**JARED**  
JEWELERS  
STORE # 0467

# Response(s) to SPI-12 Development Review Committee

**1. Proposed Development Address: 3465 Tower Place (Jared's)**

**Project Scope:** The applicant is returning to the DRC for a first look at resubmitted plans for a jewelry store on the site of the now demolished Wells Fargo bank branch location. The existing building was demolished without required approvals which triggers the application of all code requirements as it exceeds the 60% development threshold.

1 ARCHITECTURAL SITE PLAN SCALE: 3/32" = 1'-0"

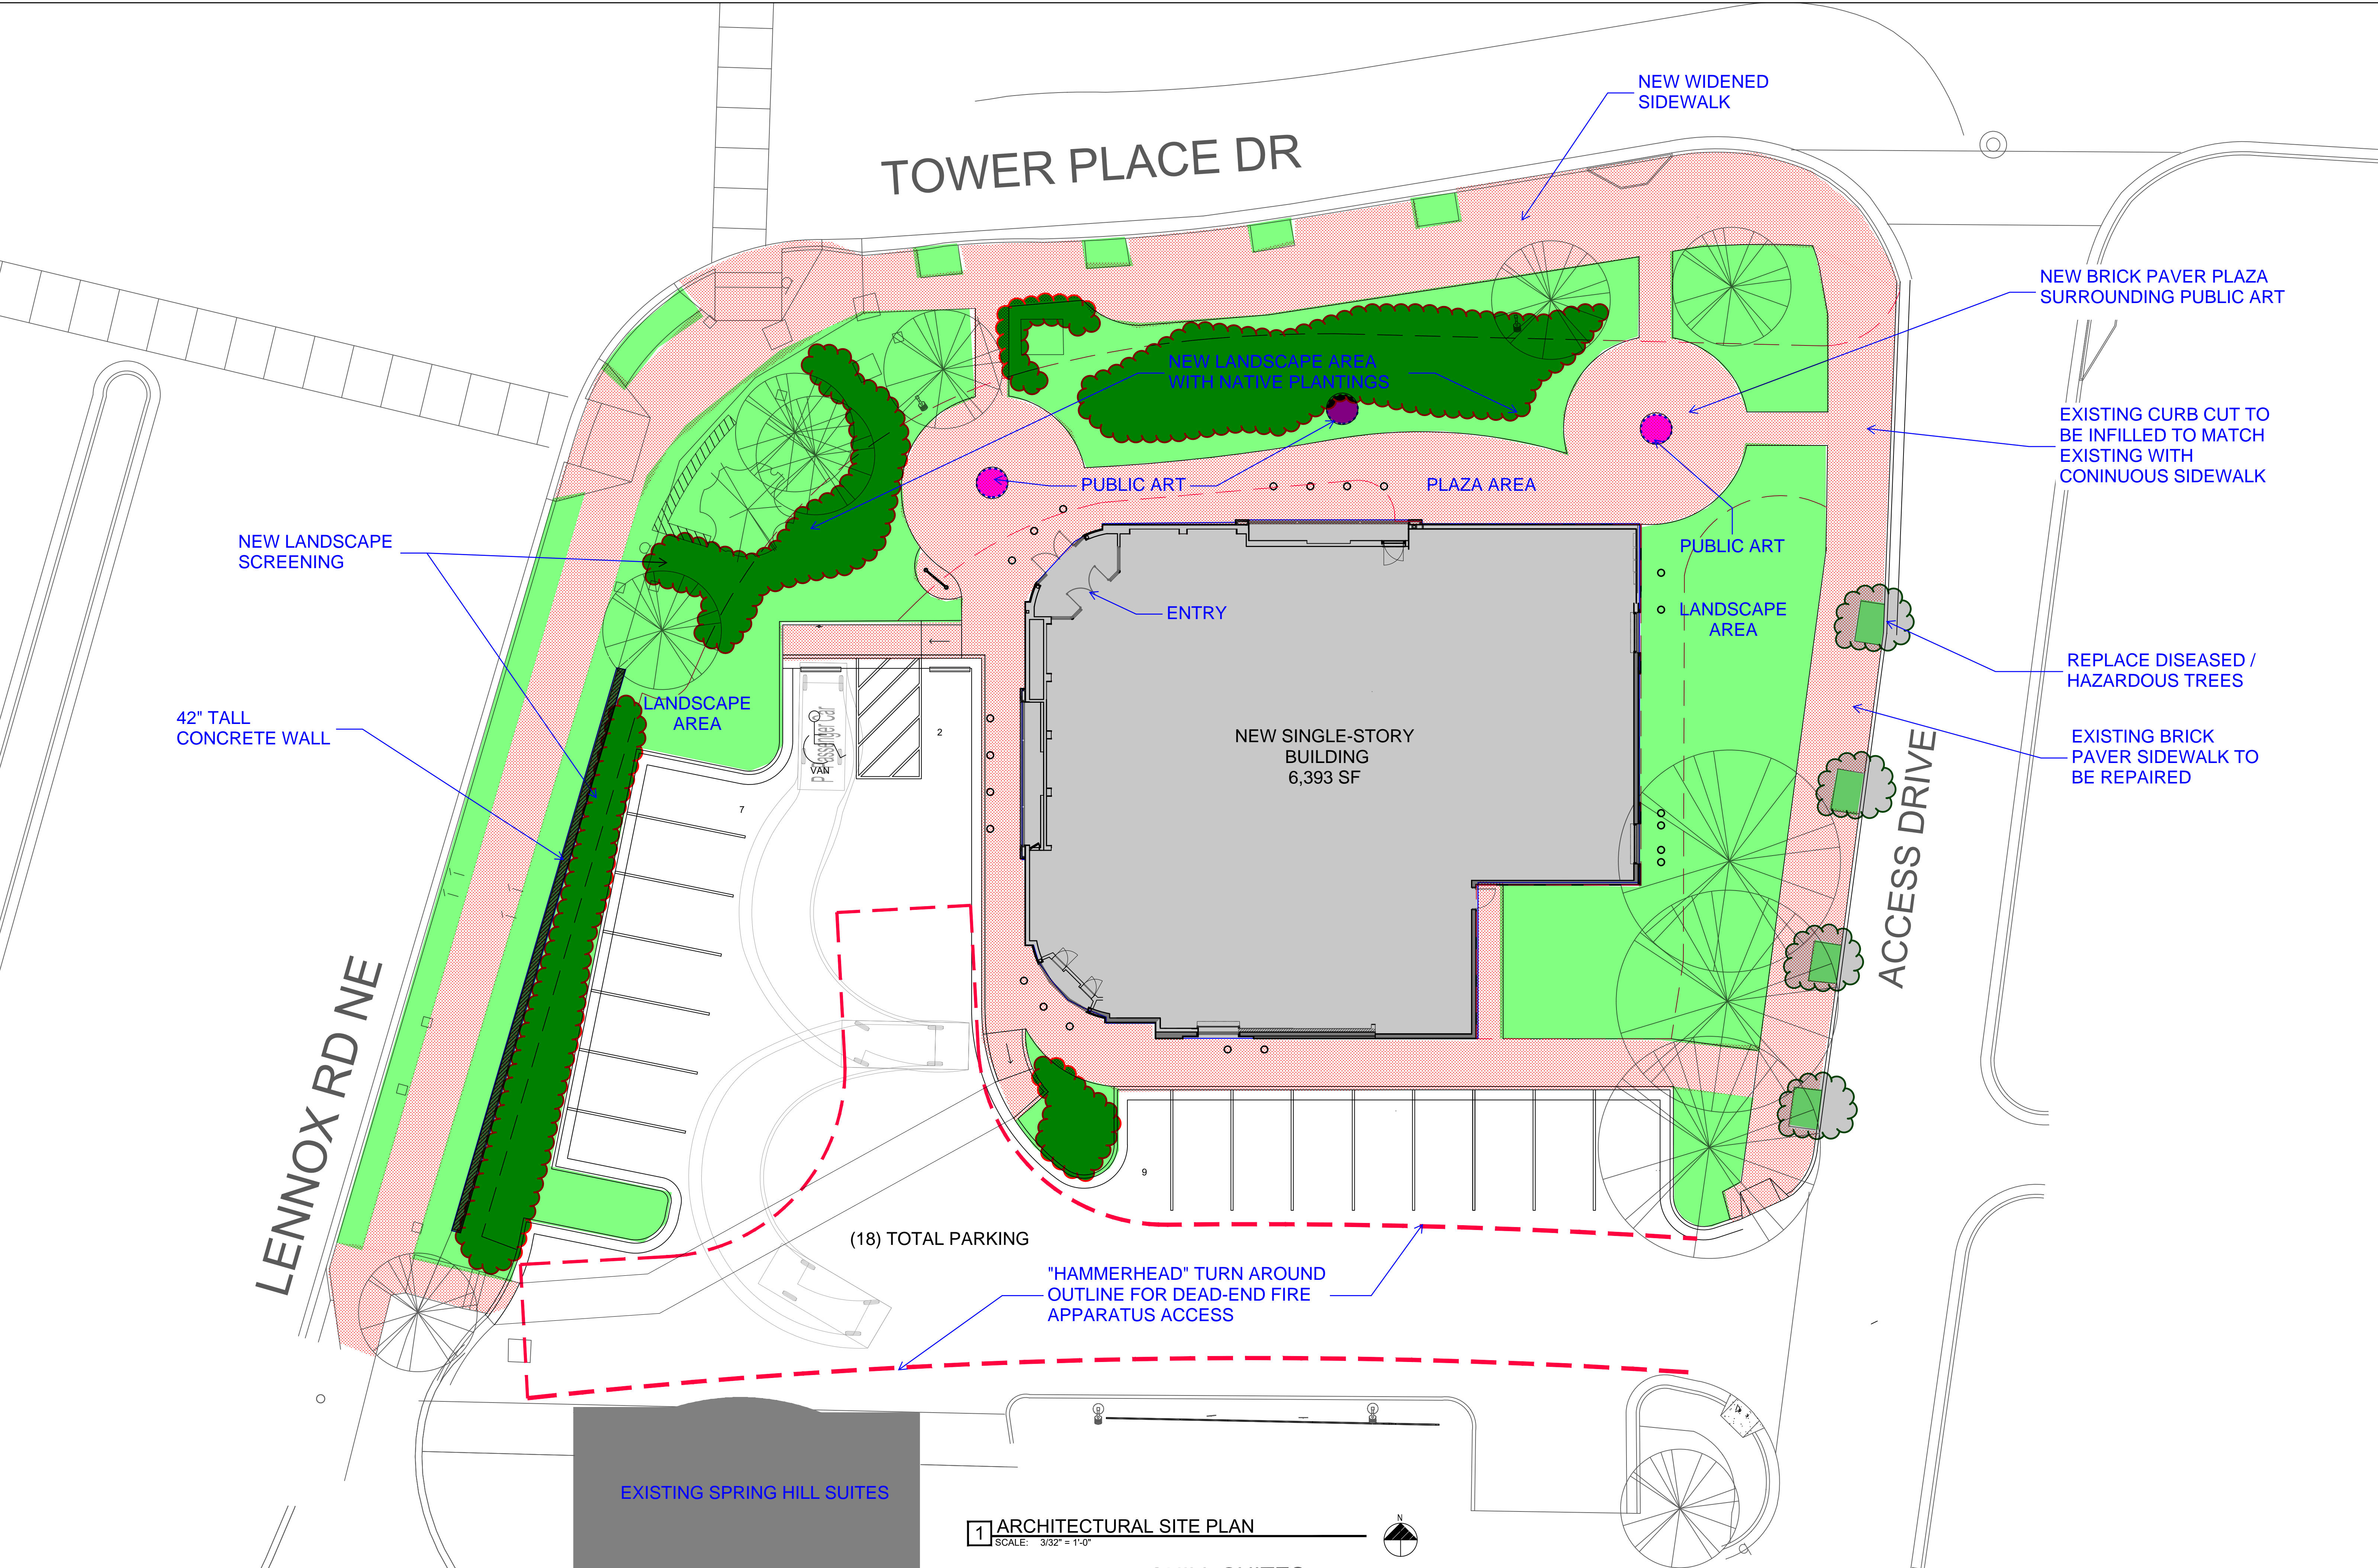
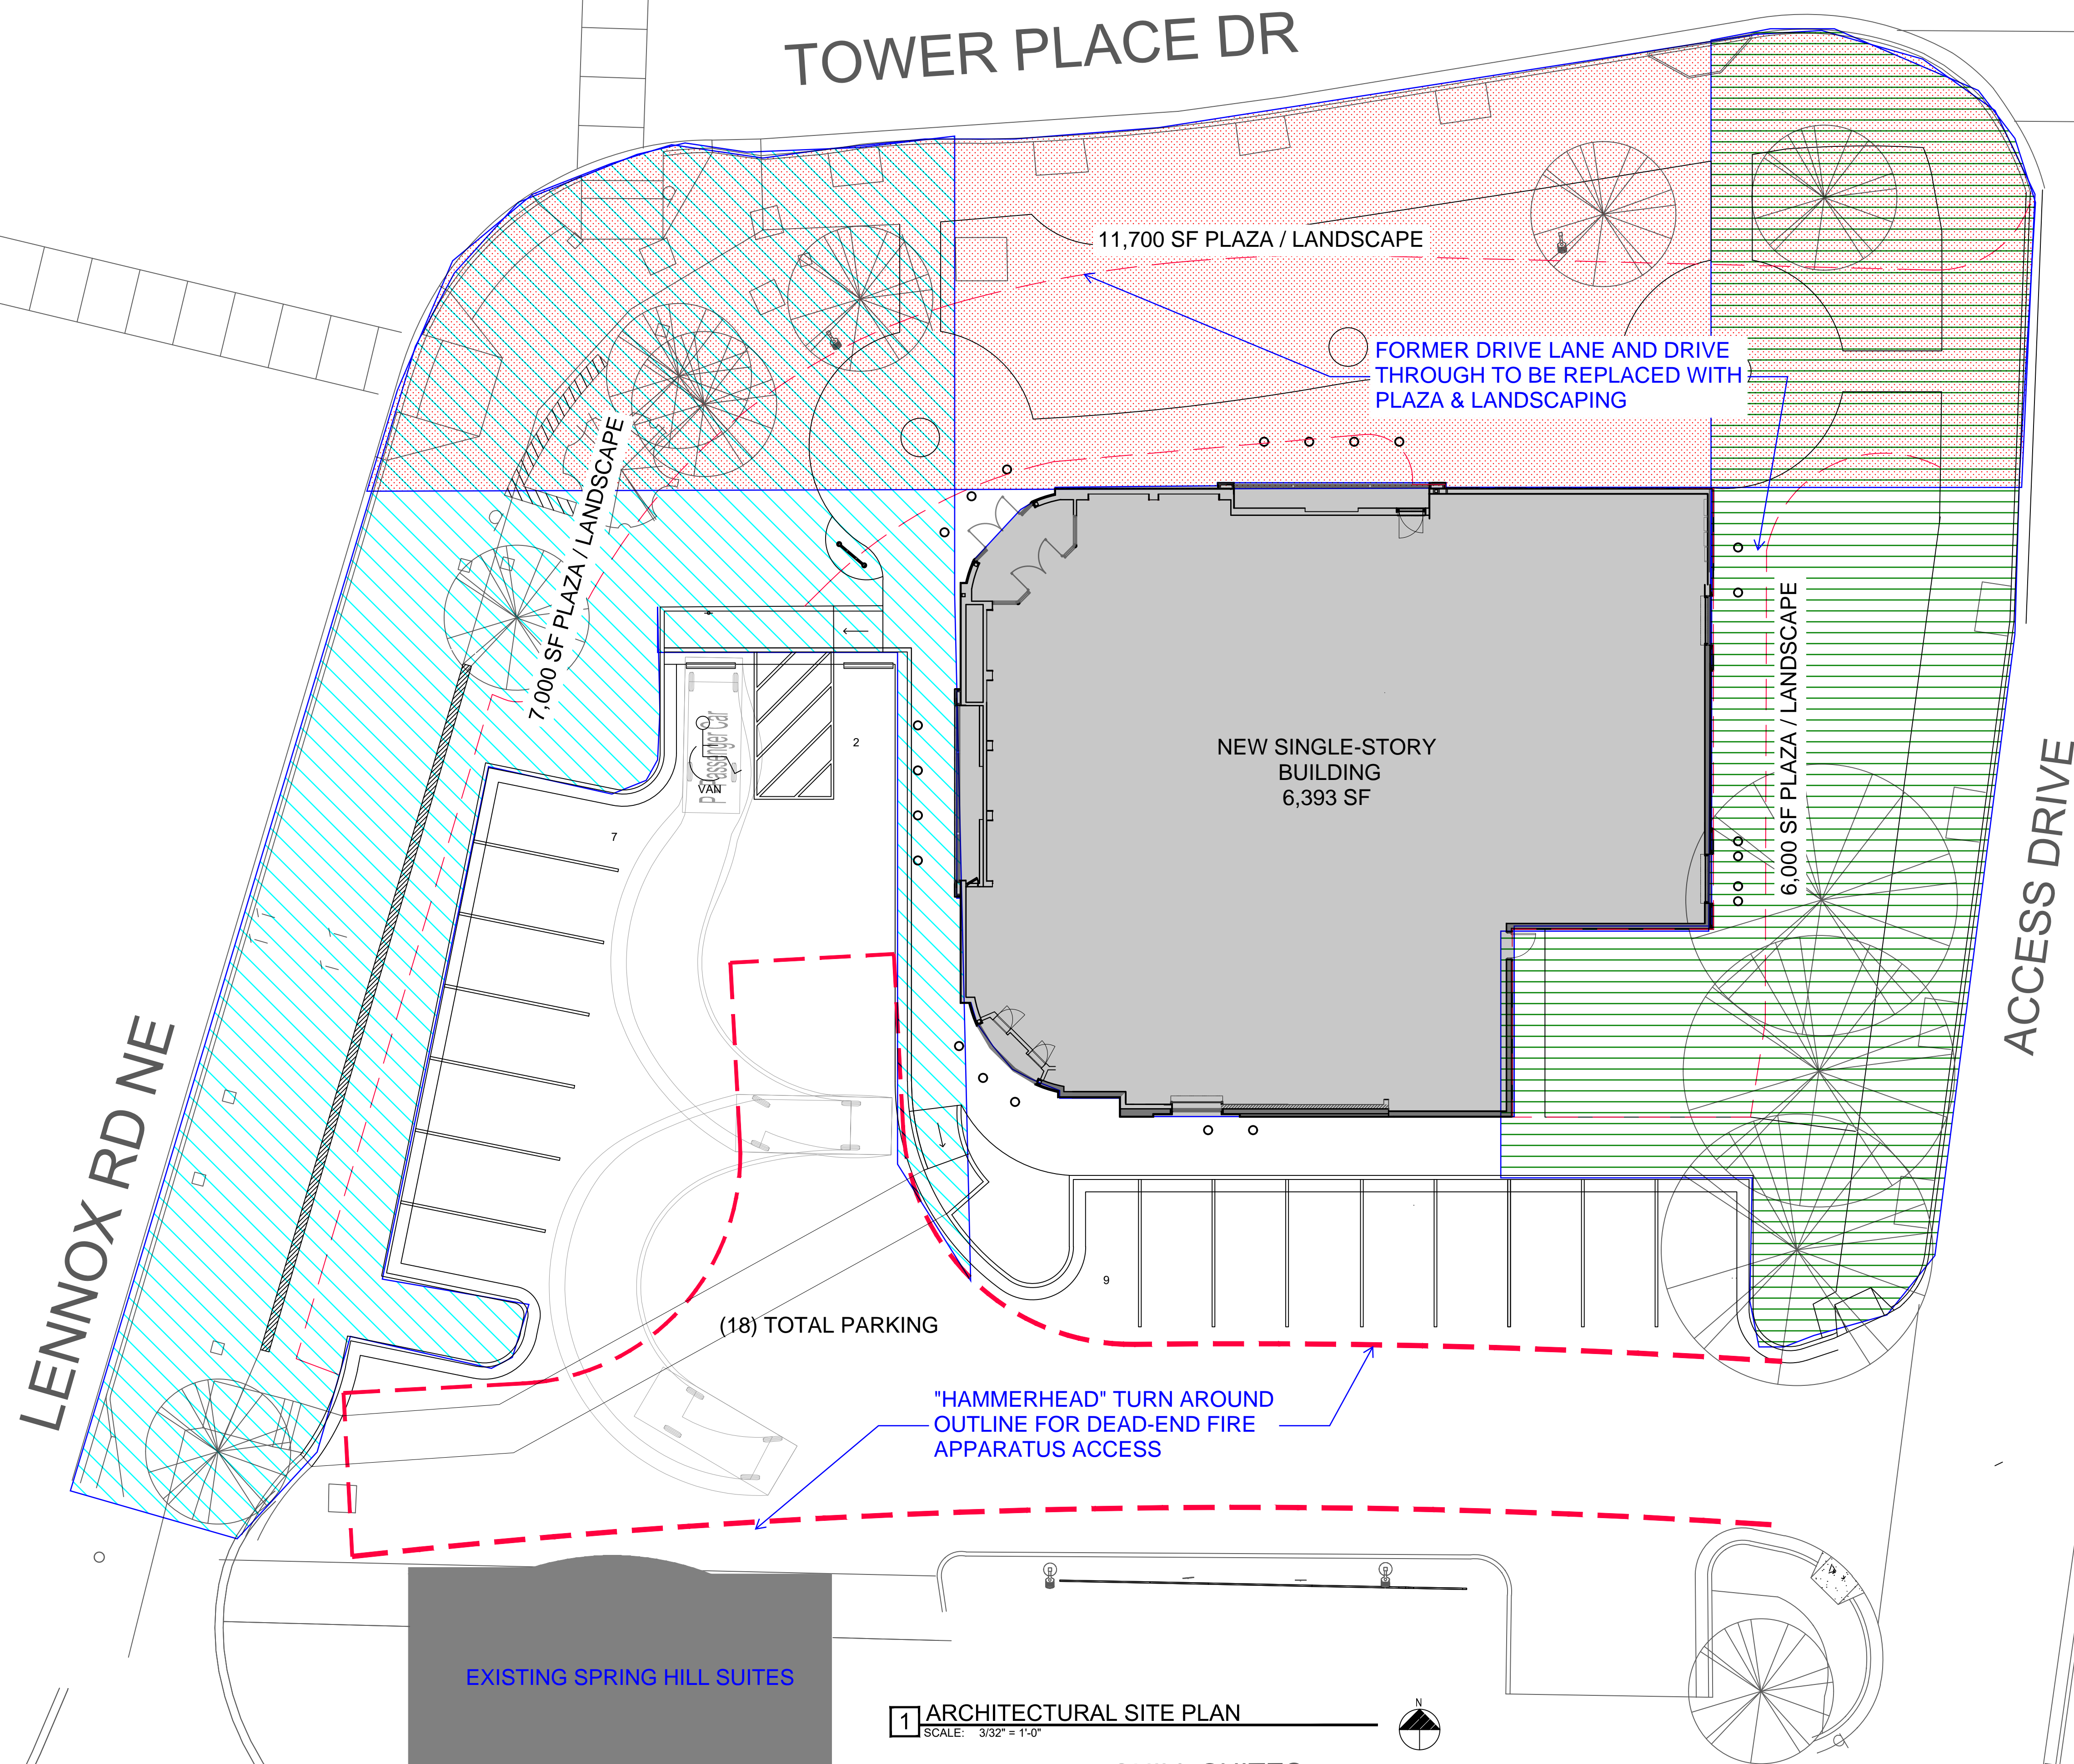
**Sec. 16-18L.008. - Open space requirements – 15% of gross floor area or net lot area, whichever is less.**

Based on a 6000 square foot structure, this would most likely be an absolute minimum of 900 square feet.

**Sec. 16-18L.009. - Sidewalks. (There are multiple requirements that need to be met in this section. These differ for both types of street frontages present on this corner lot: Lenox Road and Buckhead Loop)**

For Lenox, the requirement is 5' wide amenity zone, a 10' walk zone and a 10' supplemental zone with tree planting and lighting requirements. Given that Lenox is a GDOT road, it is not clear if they would approve for trees within the amenity zone this close to the intersection, however the applicant should make the effort to widen the sidewalks from the current 5' width.

For Tower Place Drive (which is a private street) there are no amenity or a supplemental zones required. There is a requirement to maintain a 6-foot walk zone. However, this street alignment already has a five-foot amenity zone with appropriate tree and lighting fixtures present between the walk zone and the back of the curb. Additionally, PATH400 is planned to come into the Tower Place development on the western side of Tower Place Drive adjacent to the property and the applicant should make accommodations for this community priority project.

The proposed project includes retaining parking area in front of the entrance along Lenox and a driveway from the former drive-through for the bank. This is not permitted in SPI-12

The proposed jewelry store parking lot is situated between the building and Lenox Road.

The remaining parking area not located between the building and the street should be better screened from Lenox Road. Additionally, by moving the building closer to Tower Place Drive, the remaining parking lot should have sufficient room for fire trucks to approach and leave the store or the adjacent hotel.

This should be closed off, a curb placed and the sidewalk made continuous. It is not necessary to retain.

NEW WIDENED SIDEWALK

NEW BRICK PAVER PLAZA SURROUNDING PUBLIC ART

EXISTING CURB CUT TO BE INFILLED TO MATCH EXISTING WITH CONINUOUS SIDEWALK

**Response:** Hardscape and landscaping have replaced the former drive lane around the north side of the property providing over 11,700 sf of open space between the building and Tower Place. Along Lenox (including the frontage corner of Lenox and Buckhead), approximately 7,000 sf of open space between parking and Lenox is provided. With these modifications, we far exceed the required 15% threshold.

**Response:** The parking along Lenox has been shifted a min. 5'-0" off the 42" knee wall being proposed as part of PATH 400. The design intent is to landscape the area between the proposed knee wall by Buckhead CID and the revised parking field. As the landscape area travels south, the 5'-0" is increased to 11'-4". The existing sidewalk along Tower Place Dr has increased to 14' in areas not impeded by existing utilities.

**Response:** Area north of the former footprint and former drive-through has been absorbed into new landscaping and decorative hardscape.

**Response:** Per the attached site plan, existing conditions have been adjusted to address the existing easement. We have reduced parking spaces to accommodate additional landscaping and screening by new 42" tall knee wall proposed by Path400.
